Work Order ID 105155

Item Name: Fwd Crosstube - High

Draw Nbr	Revision Nbr
D212-664-141	Rev D (DEO)

DRAWING NO. D212-664-141	TITLE XTUBE ASSY (205/212/412 HI FWD)	REV. D	DART AEROSPACE LTD ENGINEERING ORDER		D.E.O. NO. D212-664-141-D-1	SHEET NO. SHEET 1 OF 2	SCALE NTS
DRAWN	CHECKED	MFG. APPR.	APPROVED	DE APPR.			
DATE 11.04.07	DATE 11.04.11	DATE 11.04.12	DATE 11/04/12	DATE 11.04.12

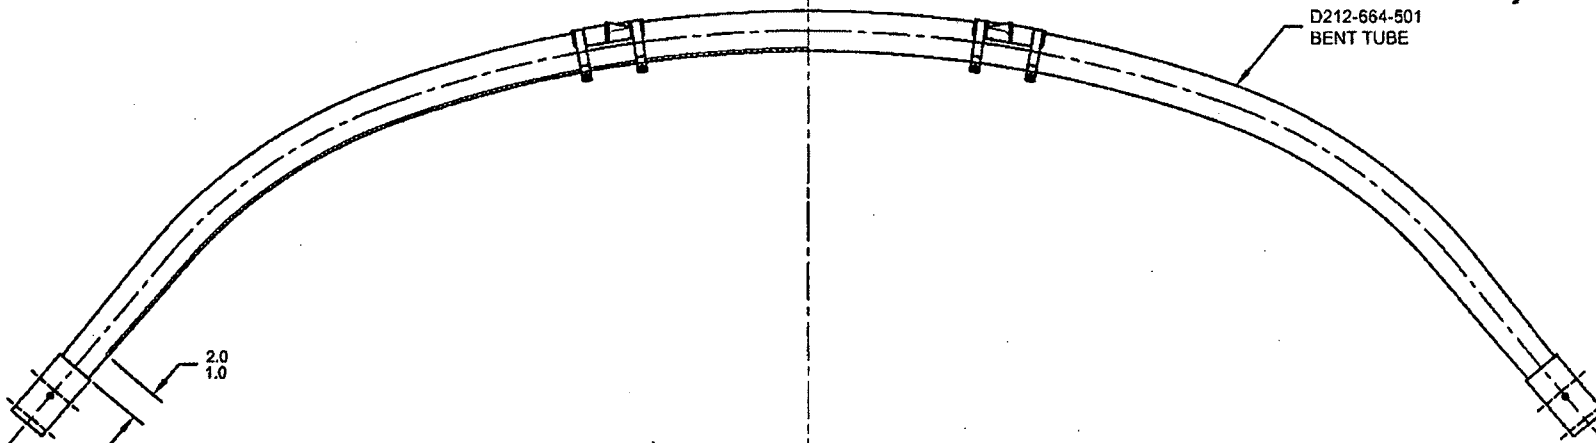
ADD AN INSPECTION WINDOW TO UNDERSIDE OF CROSSTUBE.

NOTES 2 OF SHEET 1 IS AMENDED AS FOLLOWS:

- 2) FINISH: CHEMICAL CONVERSION COAT PER DART QSI 005 4.1  
PRIME INSIDE AND OUTSIDE PER DART QSI 005 4.2  
MASK UNDERSIDE OF CROSSTUBE AS SHOWN (HATCHED AREA) AND  
PAINT OUTSIDE PER DART QSI 005 4.2  
REMOVE MASKING AND APPLY CLEAR COAT

MASK AREA PRIOR TO PAINTING,  
REMOVE MASKING AFTER PAINT  
AND APPLY CLEAR COAT

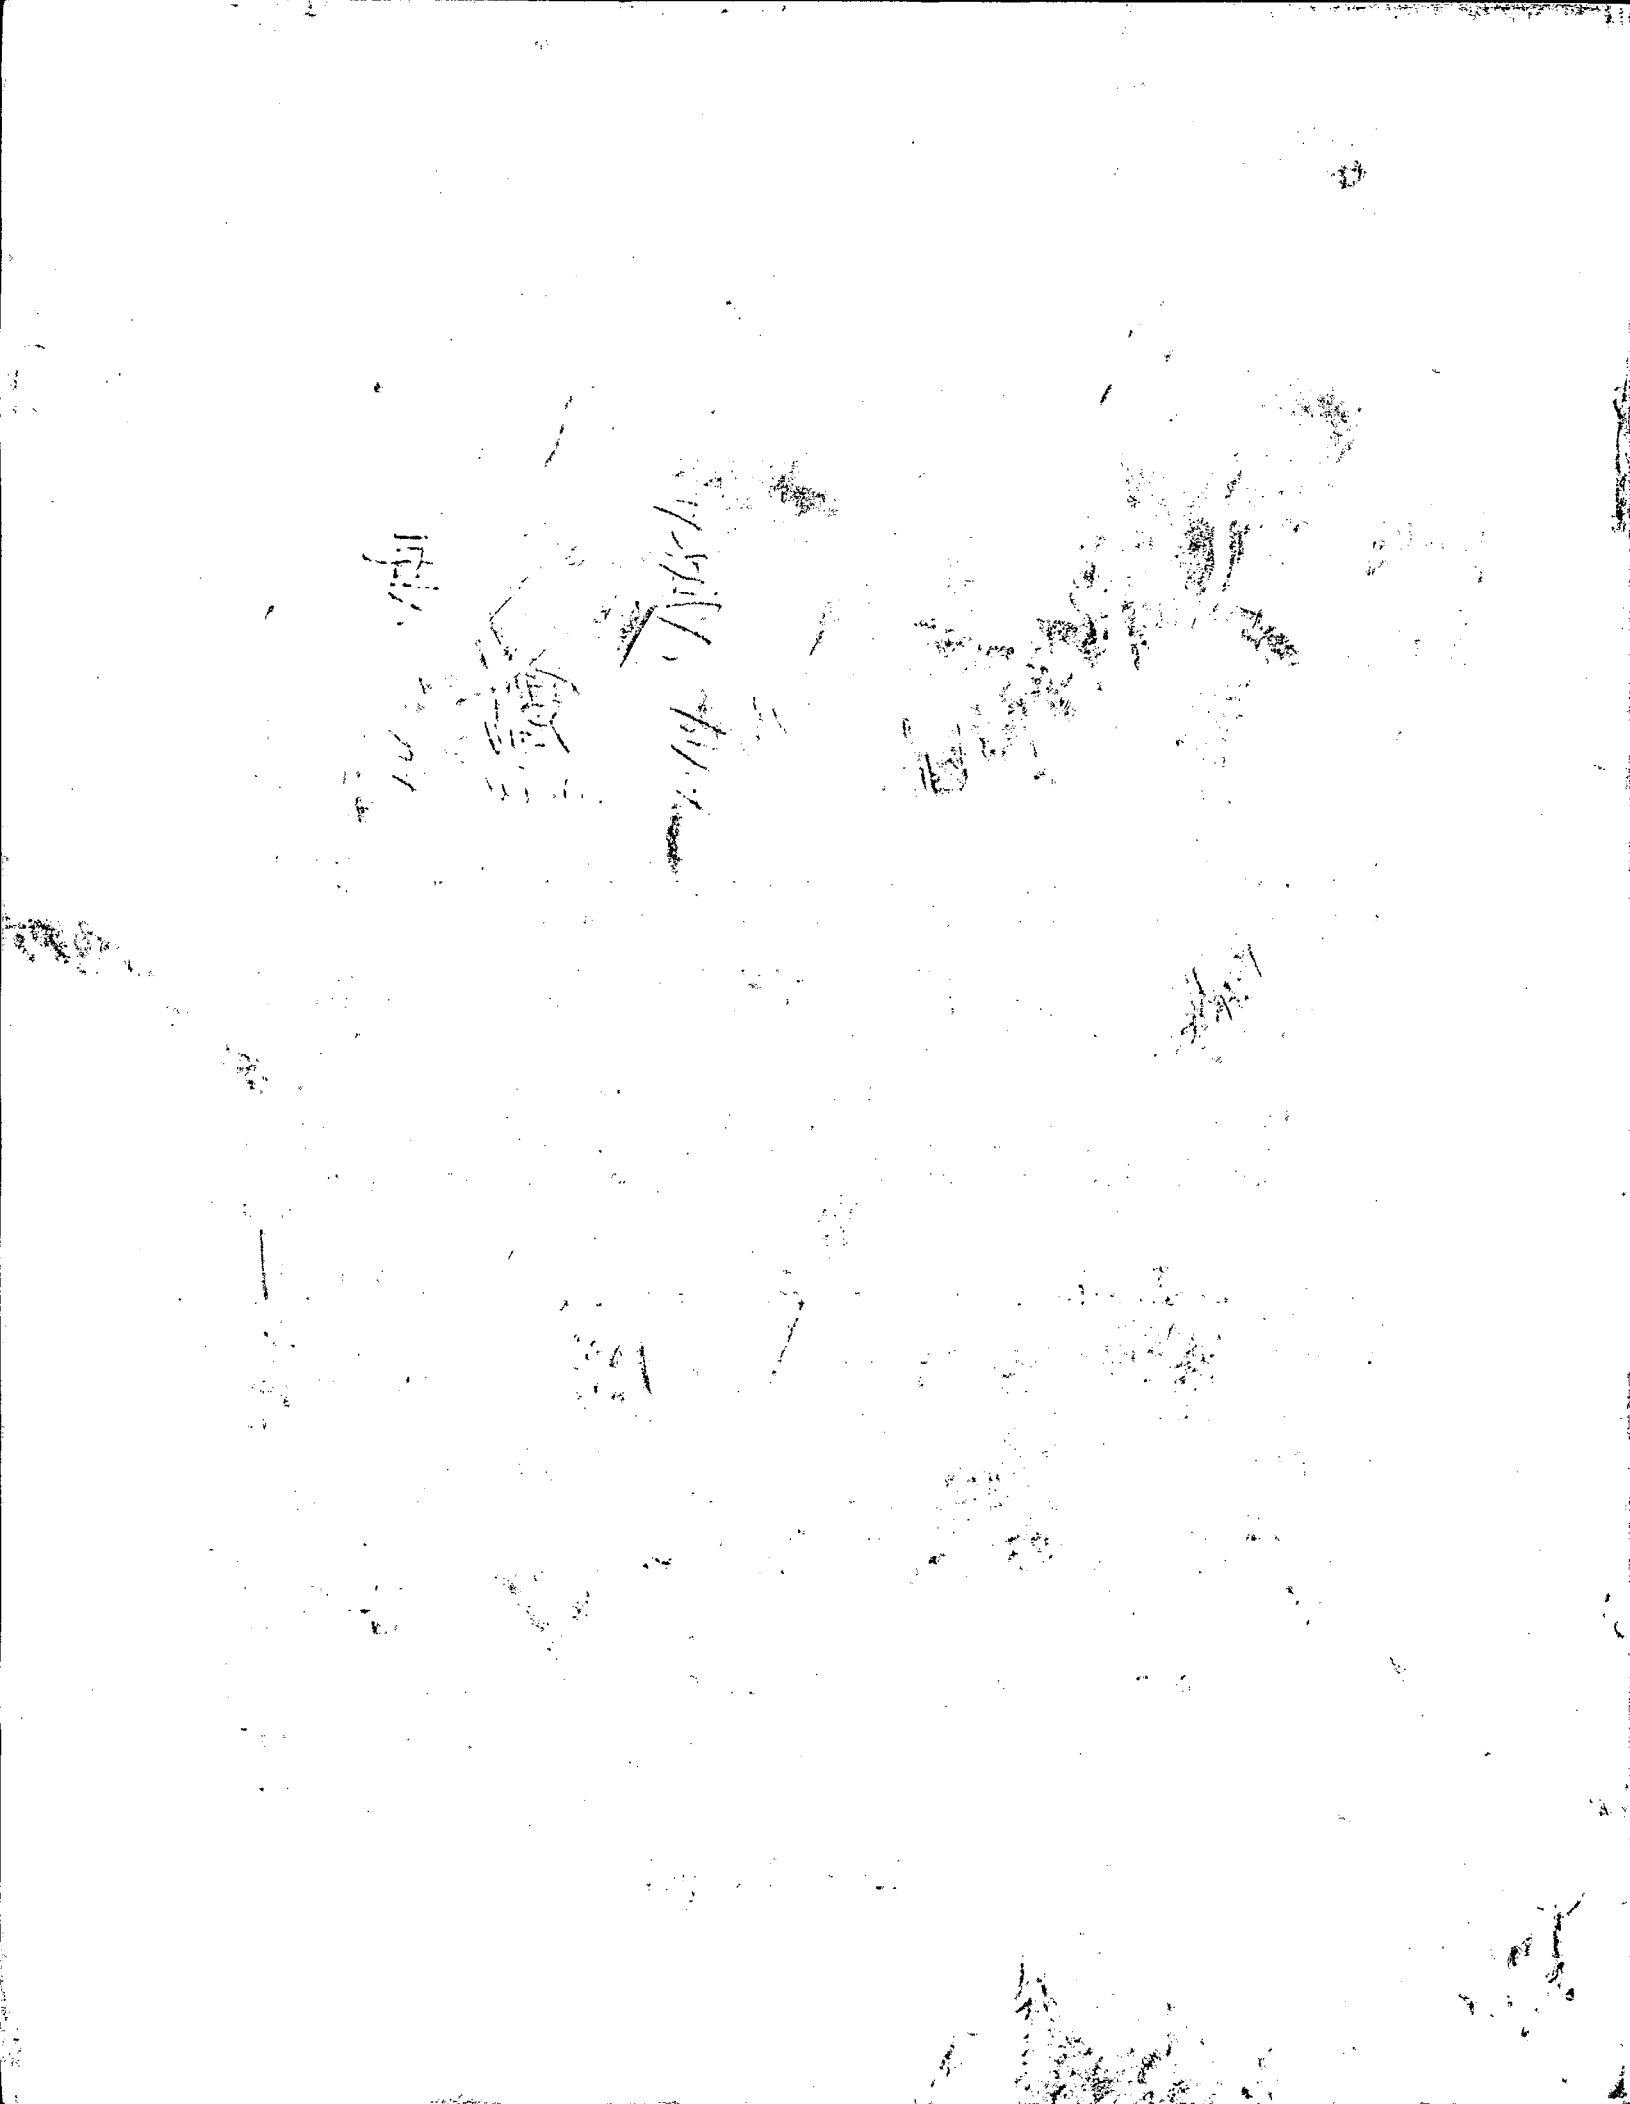
- underbent midde by approx 0.060". was unable to reach nominal dimensions. scrapped tube after rebending middle to achieve nominal dimensions. "midde fix after sides are bent" was over effective, it runs from centre line out. therefore. DO NOT underbend middles, and use caution if using "middle fix after sides are bent" program. jw 12/6/1

- have been bending middles exactly to outline on board (middle auto, middlefix1). and this resulted in tubes turning out very well. side bends, we ran 1,2,3, check, 3ccc, 3ddd and tube was nicely finished. both measures were jut passed minimal tolerance.

If tube isn't bent enough run 3aaa and up as required to finish. .checking between each program..  
... 2000 for Y and 3735 for W..
